PROJECT NARRATIVE ADDENDUM

Maravilla Scottsdale Phase 3 - Senior Living Community

Case Number: 80-DR-2006#3

Response to City Review Comments Dated July 22, 2012

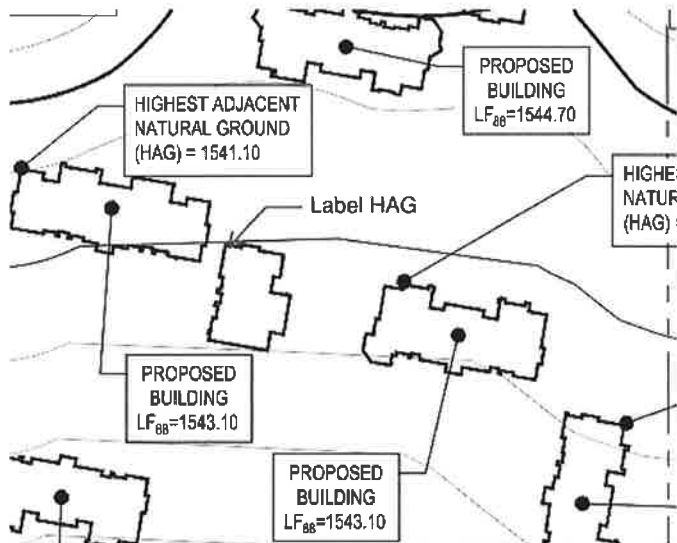
12. The provided FLO-2D exhibit was illegible (see below). Please update the Basis of Design report to provide a better copy:

We are not sure why this exhibit was not legible in your copy of the report. Perhaps the file was corrupt when saving down for DRB submittal. In any case, if the resubmittal copy is still not legible, please contact us and we can email you a copy - Reference Exhibit 6.
